GOVERNMENT OF THE DISTRICT OF COLUMBIA
DEPARTMENT OF TRANSPORTATION

MEMORANDUM

SUBJECT: ZC Case No. 06-46B – Square 701 - Half Street Residential PVC, LLC

Figure 2 Site Circular Driveway Plan (Source: Wells & Associates)

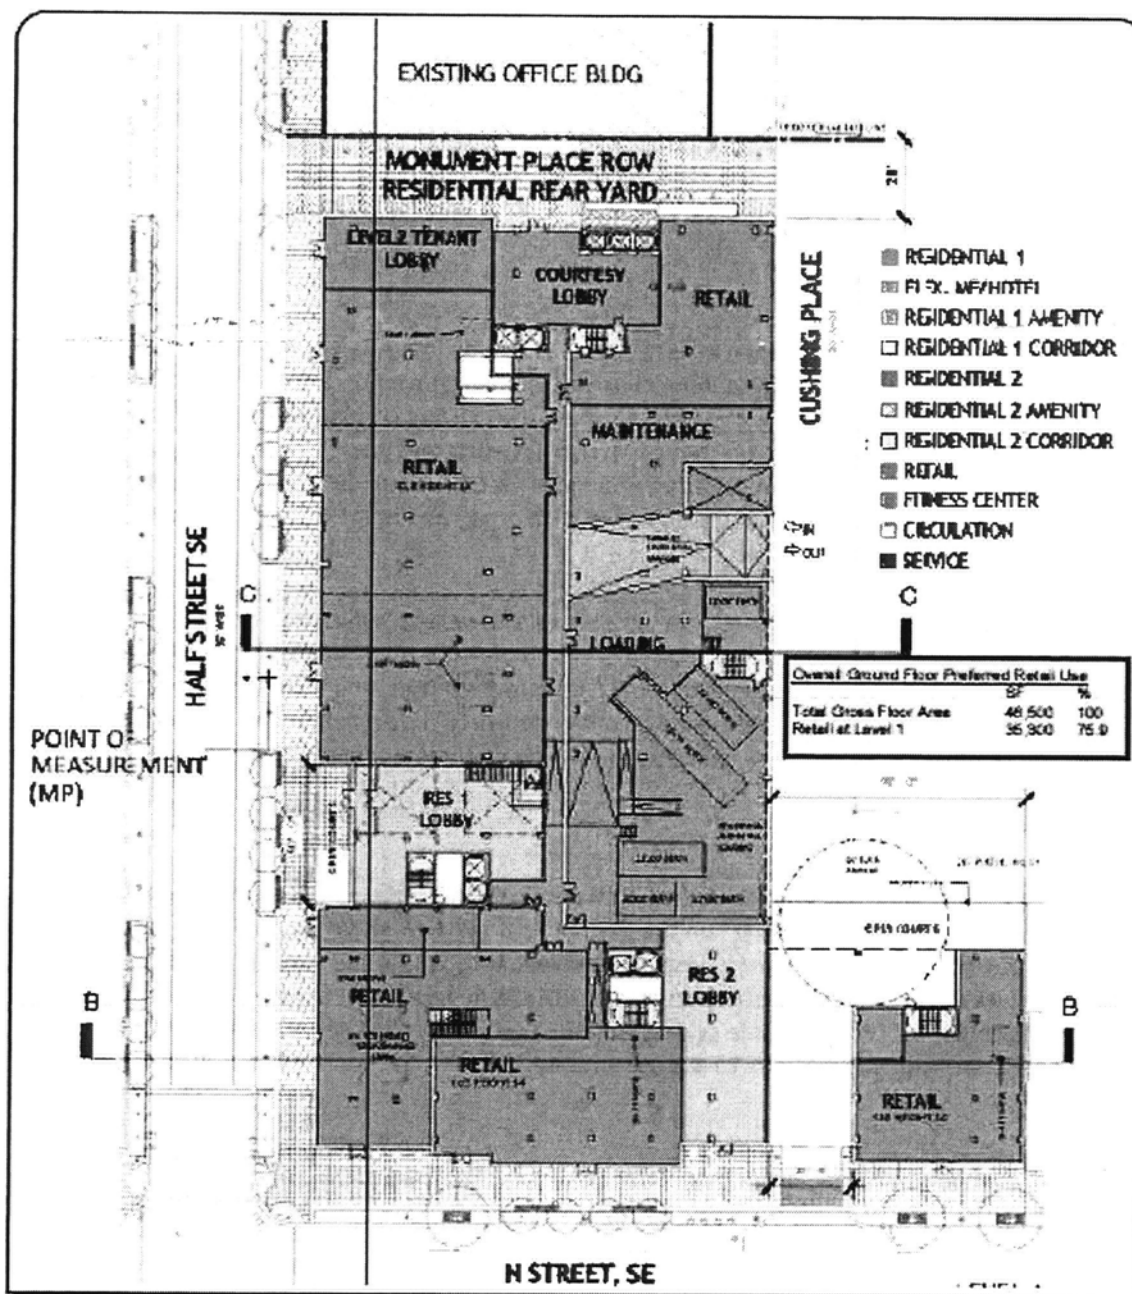
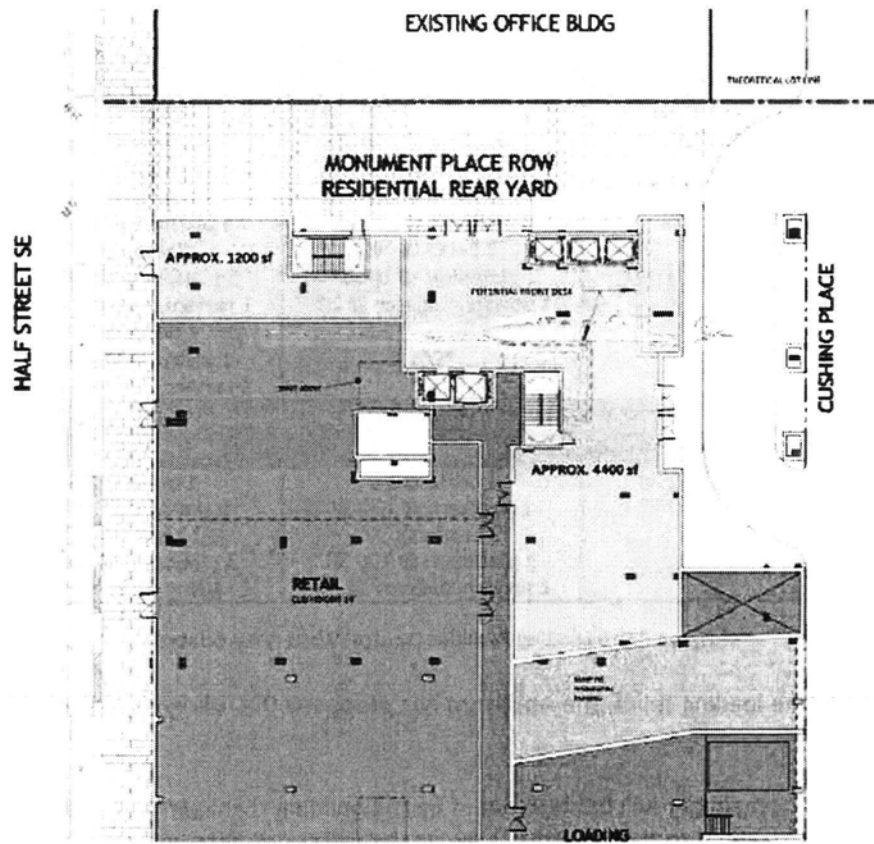
Under the two hotel options, the Applicant has proposed a circular driveway off the alley. DDOT understands the desire to create a pick-up and drop-off area for guests during Ballpark games when Half Street is closed, but given the extensive parking and loading activity associated with this and other projects along this alley, the driveway has the potential to exacerbate conflicts. In addition, taxis and drivers will not know to turn onto an alley to find the hotel lobby. Lastly, the proposed driveway will further increase volumes at the intersection of the alley with M Street, creating additional delays and impacts.
